# Development Application Access Review

## Orange Fields 44-50 Tench Ave Jamisontown NSW

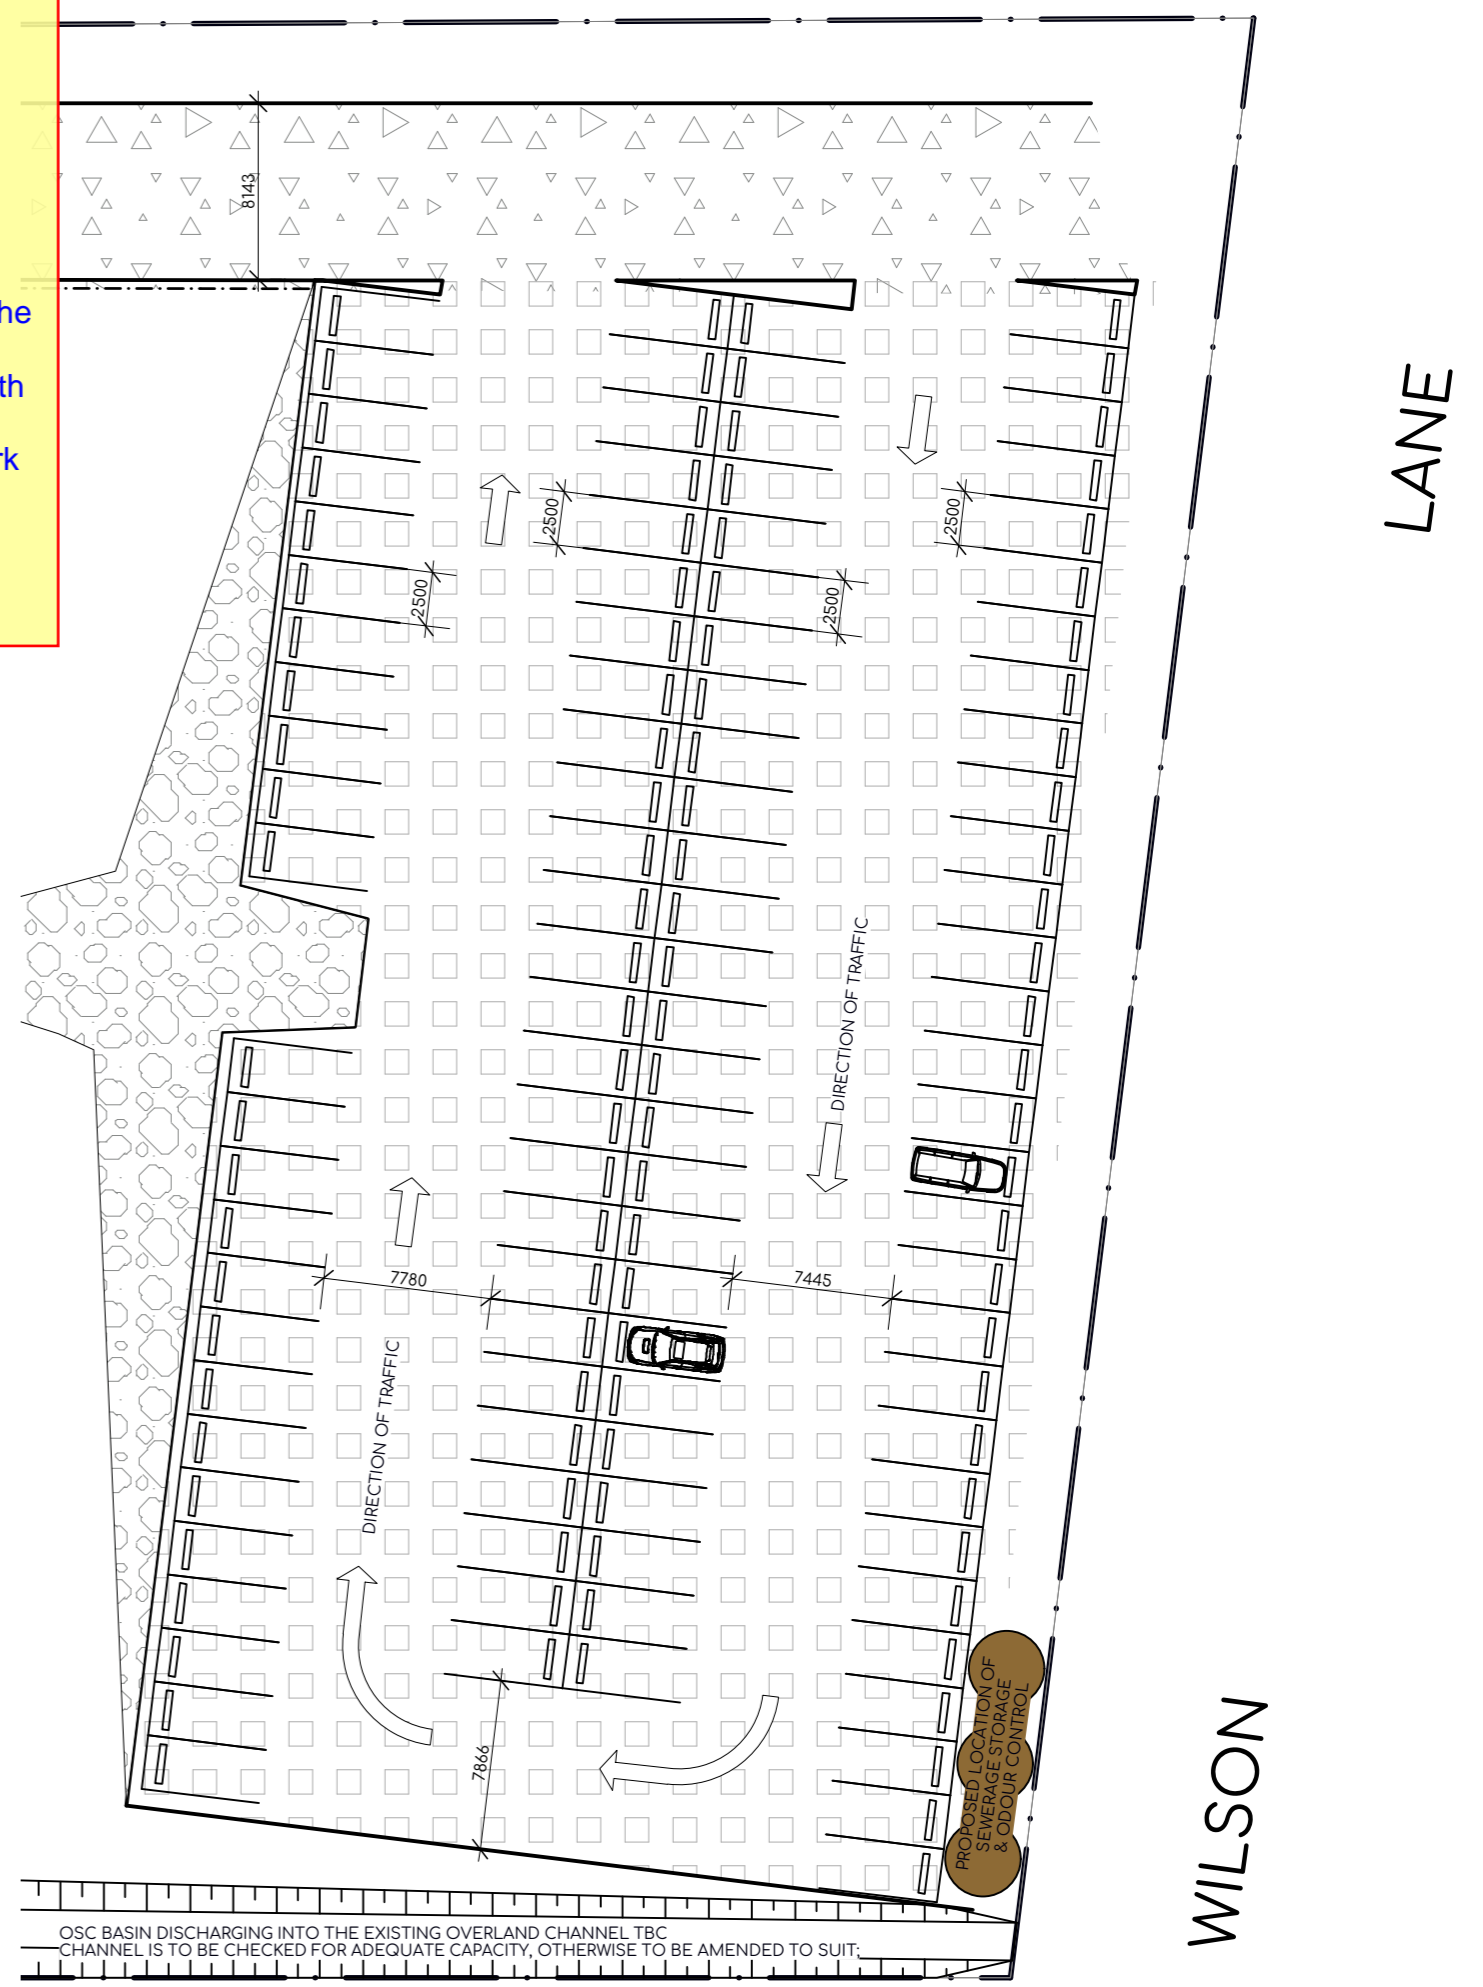
Coordination notes requiring clarification/confirmation.
